ATTACHMENT 1: MARCH 8, 2022 STAFF REPORT

MEMORANDUM

Date: November 5, 2020
RE: Real Estate Equities Final PUD
application for a Senior
Development at 1795 Eustis Street

6'-0" High Privacy Fencing:
Cedar, Board on Board

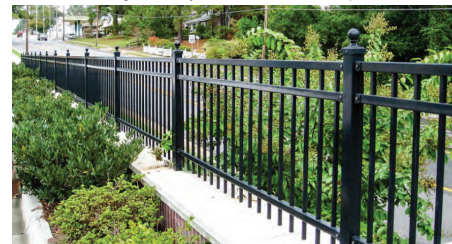
Condition numbers 15 and 16 address the southern property line of the subject Project, and the intent of the conditions was to ensure adequate screening is provided between the proposed Project and adjacent single-family residential uses. The Landscape Plan has been updated to reflect a mix of both deciduous and conifers along the southwestern portion of the property line, and a 6-foot cedar board-on-board fence is proposed along the southerly property line to achieve 100% opacity at ground level. The fence detail is provided on Sheet SD_000. **As proposed, the Applicant's updated submittal meets conditions 15 and 16 as required in the Resolution.**

3 Site - Monument Sign - Section 1
3/4" = 1'-0"

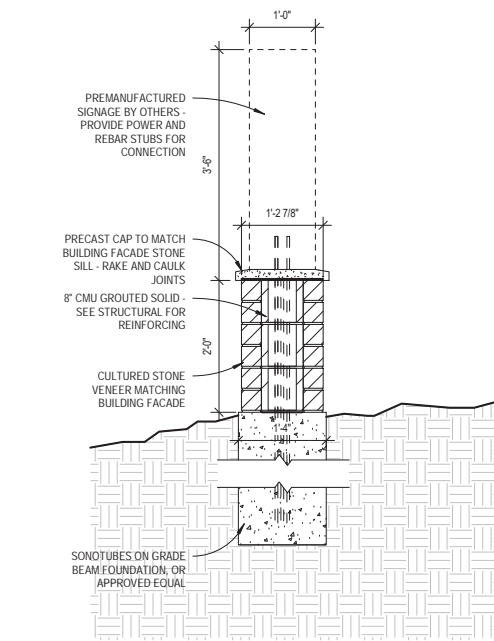
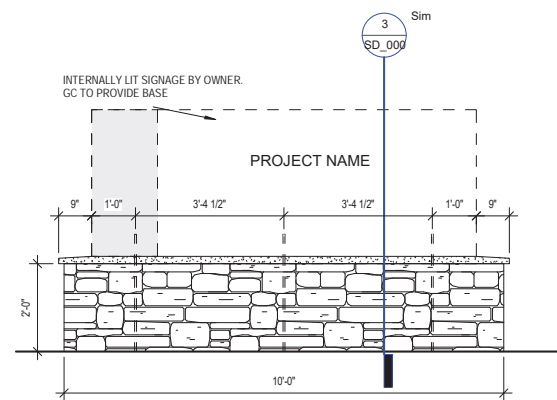
Sheet SD_000 provides an elevation and section of the proposed monument sign (which is defined as a Ground Sign based on the proposed dimensions as defined in Section 10-10-2) and is located on the north side of the entrance driveway to the Project (Attachment C). As denoted the monument sign is approximately 5'6" tall from grade and is approximately 1"4" wide at the base. The sign is approximately 10' wide at its widest point, and the sign area is set on top of a stone-clad base. As denoted the sign is proposed to be internally lit (illuminated), and there is no name identified for the proposed Project.

C8-1

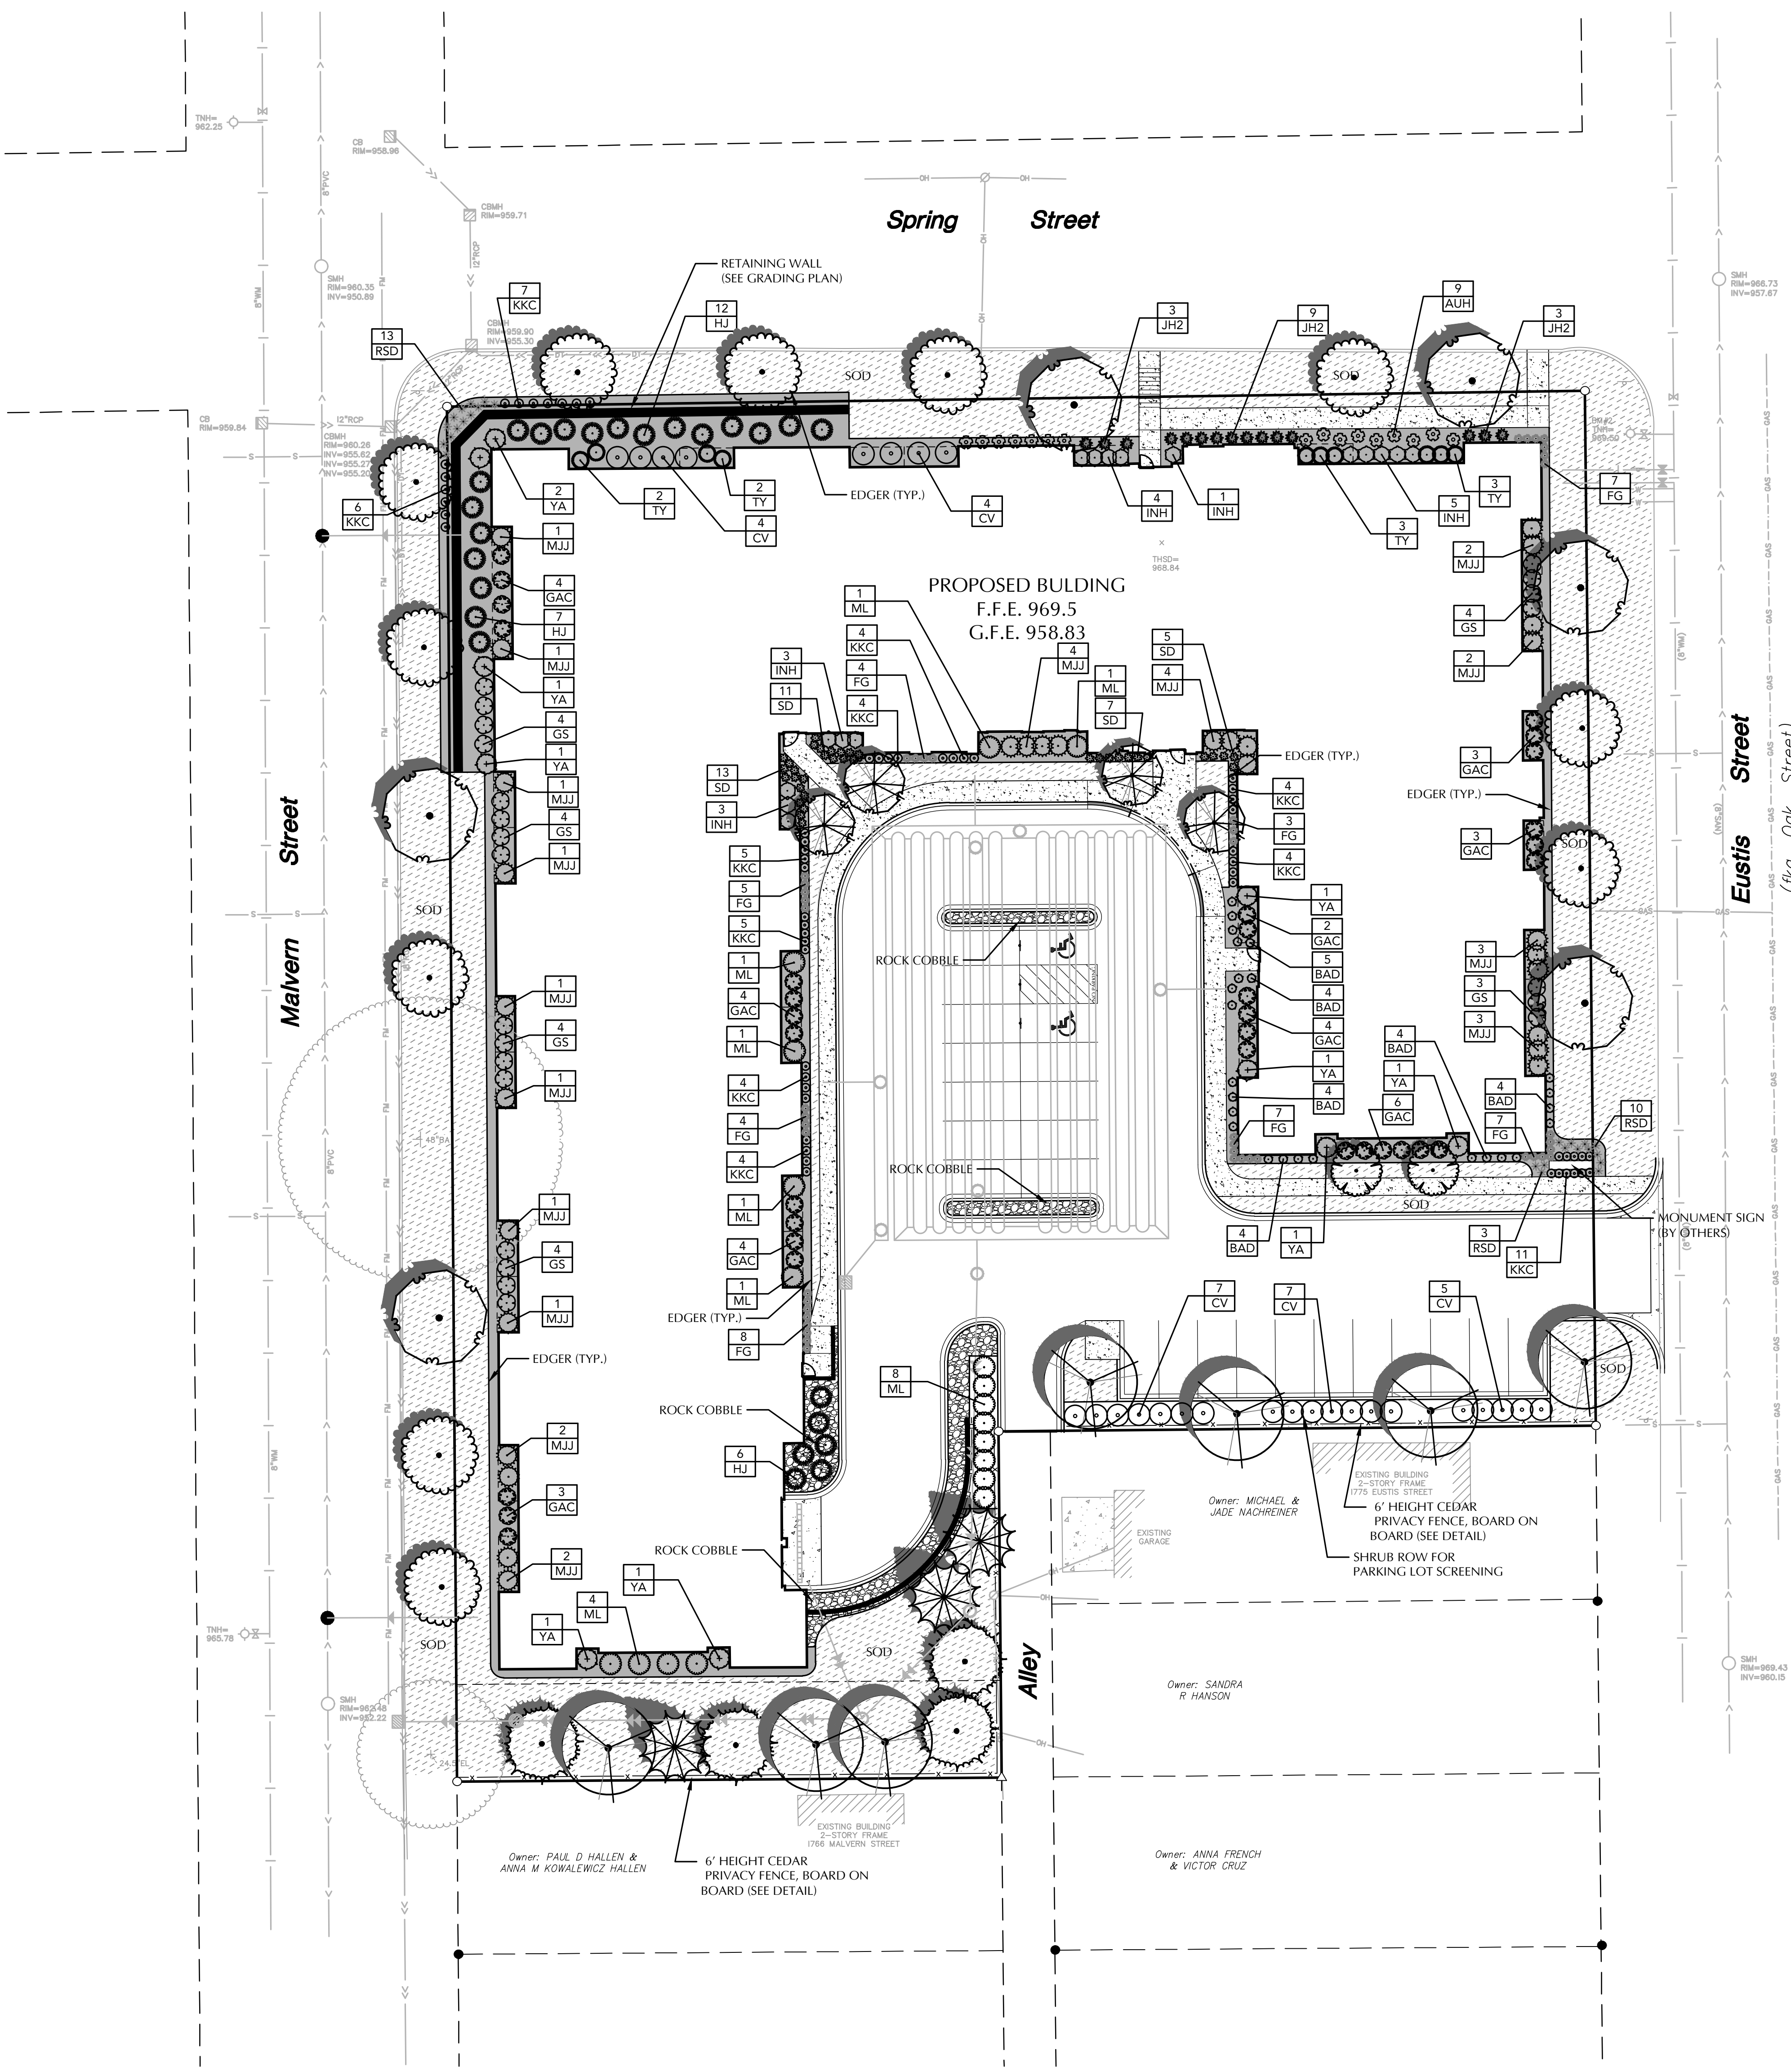
Condition number 20 requires additional details regarding hardscape materials be provided, including the retaining walls. A detail regarding the retaining wall is provided on sheet C8-1 of the Civil Plan set which describes the retaining wall materials as a modular block with a cap. While the profile detail looks acceptable, staff believes it is important that the color and material palette of the retaining walls on site is reviewed to ensure consistency with the materials and colors as shown on the submitted Materials Board. **Staff would recommend including a condition in the Final PUD approval that the colors and materials of the retaining wall shall be submitted for review and approval by the City Staff prior to a building permit being issued for the structure.**
